Access Compliance Report

Public Rights-of-Way

(Curb Ramps)

Intersection ID: 13118	Main Street: E_7TH_ST	Cross Street: CENTRAL_AV	Location: S
ADA ID: EA2C8E792AE9	Ramp Type: Para	Initial Pass/Fail: Fail	Overall Compliance: No
Severity Score: 13.75			
Codes/Mitigation Info/Possible Solution		Field Measurements/Component Compliance

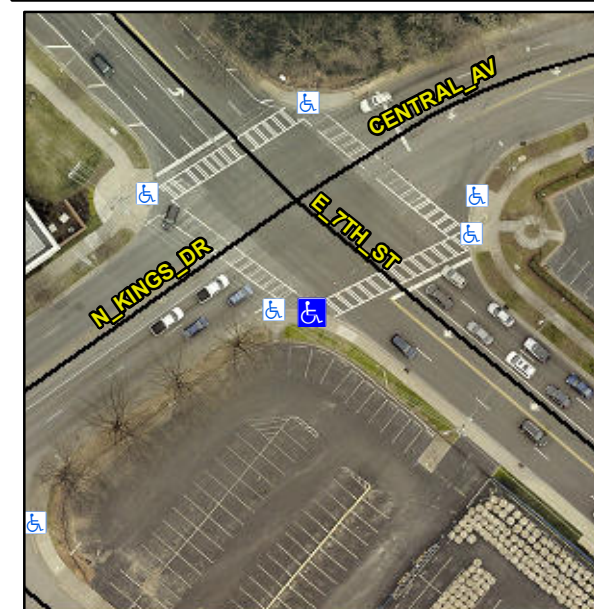
RT RP < 5%

R304.3.2, R304.5.3

Compliance	Description	Data	Compliance	Description	Data
N/A	Ramp Length LT (in)	61.5	N/A	Ramp Length RT (in)	64.0
Yes	Ramp Width LT (in)	61.0	Yes	Ramp Width RT (in)	60.0
No	Ramp Slope LT (%)	9.8	Yes	Ramp Slope RT (%)	1.9
No	Ramp XSlope LT (%)	2.7	No	Ramp XSlope RT (%)	2.1
N/A	Landing Length (in)	N/A	N/A	DWS Provided?	N/A
N/A	Landing Width (in)	N/A	N/A	DWS Contrast?	N/A
N/A	Landing Slope (%)	N/A	N/A	DWS Length (in)	N/A
N/A	Landing X Slope (%)	N/A	N/A	DWS Full Width?	N/A
N/A	Landing Curb? (Y/N)	N/A	N/A	DWS Offset (in)	N/A
N/A	Shared Landing?	N/A			
N/A	Gutter Ponding?	N/A	N/A	Gutter Slope (%)	N/A
N/A	Gutter Lip Ht (in)	N/A	N/A	Gutter X Slope (%)	N/A
N/A	Painted X Walk1?	Yes	N/A	Painted X Walk2?	N/A
	X Walk 1 Direction	To NE		X Walk 2 Direction	N/A
N/A	X Walk 1 Width (in)	110.0	N/A	X Walk 2 Width (in)	N/A
	X Walk 1 Slope (%)	1.2		X Walk 2 Slope (%)	N/A
	X Walk 1 X Slope (%)	1.7		X Walk 2 X Slope (%)	N/A
N/A	Ramp inside XWalk1?	Yes	N/A	Ramp inside XWalk2?	N/A

Remove & Replace Entire Ramp.
